Central Planning Authority

Minutes of a meeting of the Central Planning Authority held on **January 4, 2023 at 10:00am in Conference Room 1038, 1st Floor, Government Administration Building, and Elgin Avenue.**

CPA/01/23

Figure 1: A plan extract showing the limited setback of the existing seawall and the pool deck from the MHW of the cove (Source: John Doak Architecture 2022)

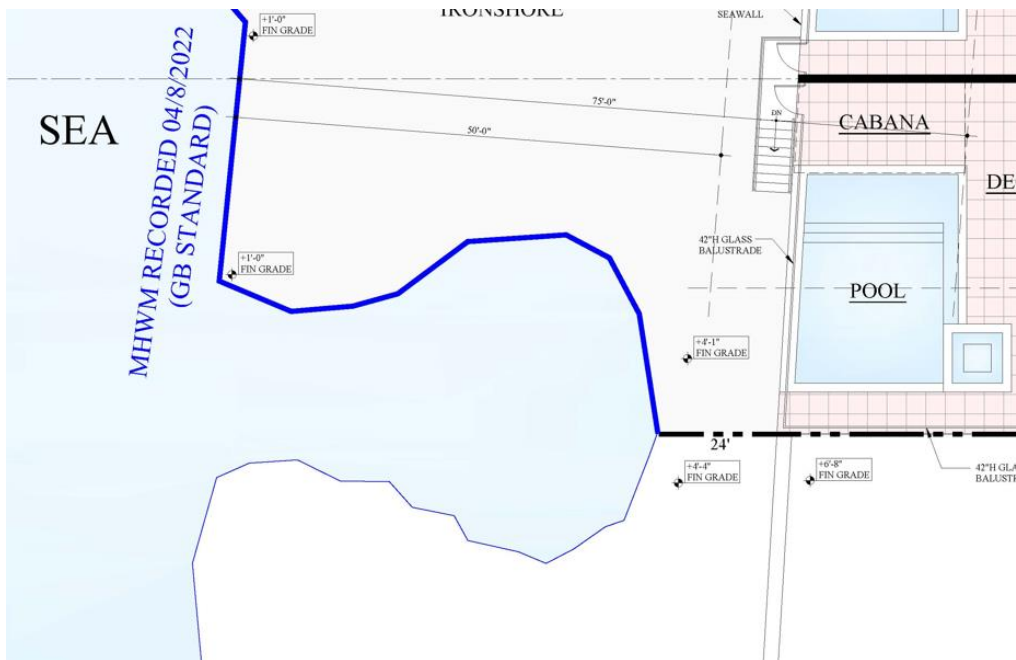
The DoE is also concerned about the limited setback of the edge of the seawall and pool deck from the MHW as it relates to the natural cove inlet on the coastline of the parcel. Although the plans show measured setbacks from part of the coast, they do not account for the setbacks relative to the MHW of the cove. As can be seen in Figure 1 above, the setbacks of the existing seawall and proposed pool deck are limited (approximately 12 ft). There are several examples of similar developments in this area which have experienced storm impacts or undermining of structures to such

Figure 1: DOE's 2013 habitat map extract showing the application site outlined in red.

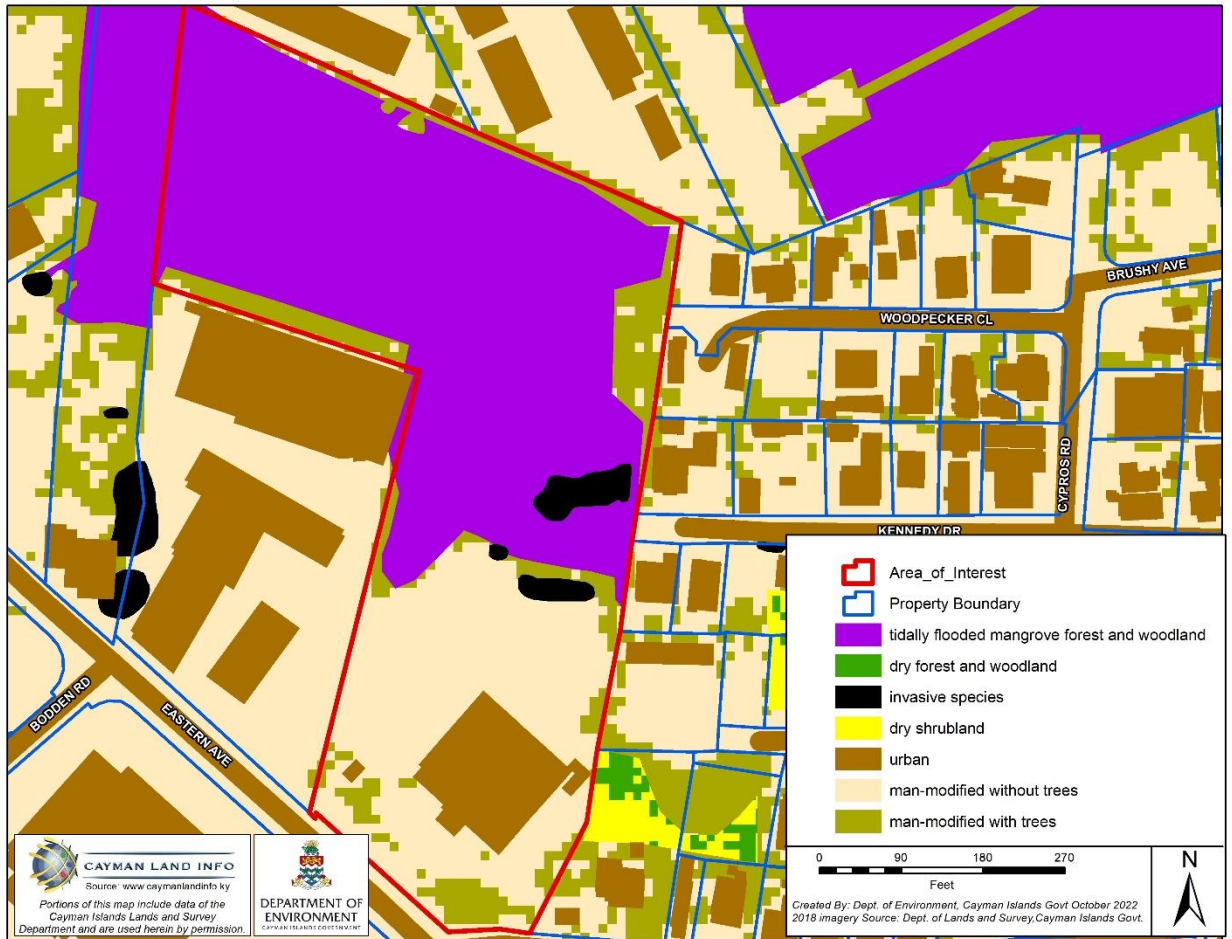
The northern part of the subject parcel consists of primary habitat classified as tidally flooded mangrove forest and woodland, as shown in Figures 1 and 2.

Mangroves are protected under Schedule 1, Part 2 of the National Conservation Act (2013). **It is an offence to remove mangroves unless permission is explicitly sought to remove them either through planning permission or a National Conservation Council Section 20 permit.**

As mangroves are protected under the National Conservation Act (2013), all mangrove vegetation shall be retained in accordance with the National Conservation Council's Species Conservation Plan for Mangroves (2020).

- 1. All mangrove vegetation shall be retained in accordance with the National Conservation Council's Species Conservation Plan for Mangroves (2020).*
- 2. There shall be no land clearing, excavation, filling or development of the resultant subdivided parcels without planning permission for such works being granted.*

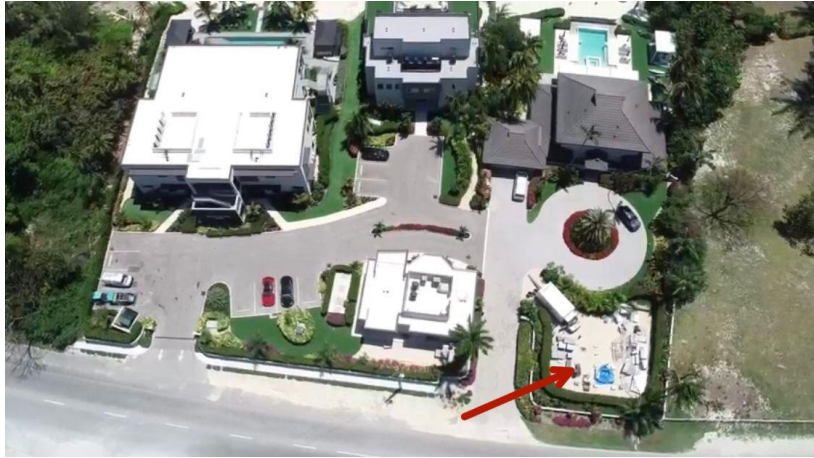
In response to the Central Planning Authority request, "The applicant is required to submit revised plans showing the visual appearance of the containers in keeping with the quality of the resort, for the Authority's consideration", we submit the following.

- 1. Picture one (1), showing an arial view of the property indicating where the prefabricated tiny home units will be placed. It also shows that it is to the front of the property with a 10 foot hedge that encircles the entire area.*

Figure 3: Cayman Land Info 2018 aerial extract showing the excavated facility at Spanish Cove.

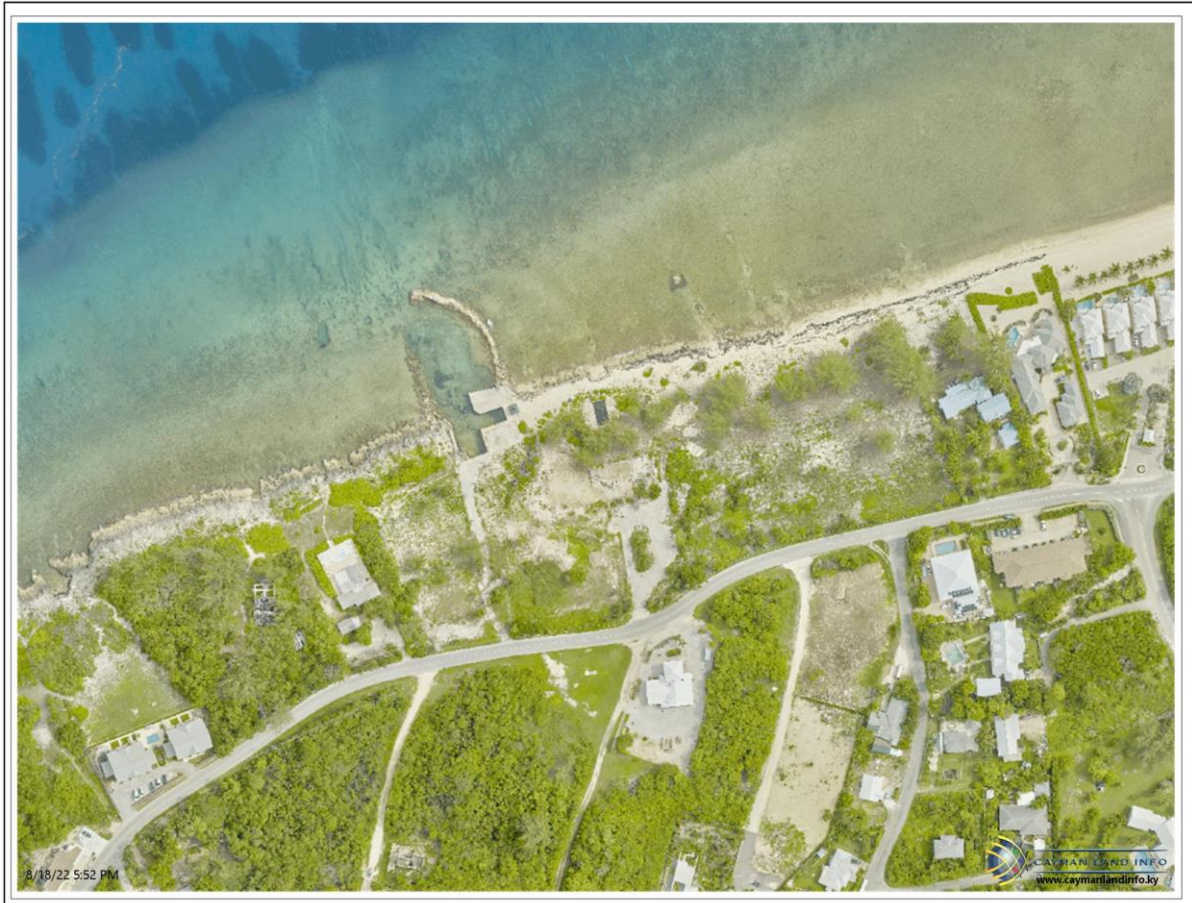
Spanish Cove, located to the west of the site along the same coastline, operated as primarily a dive resort. In order to facilitate watersports at that development, extensive modifications of the seabed were undertaken in the 1980s/1990s as shown in Figure 3 below. However, there are healthy seagrass beds offshore and the DoE would not support the dredging and construction of a similar facility at this location within the MPA.
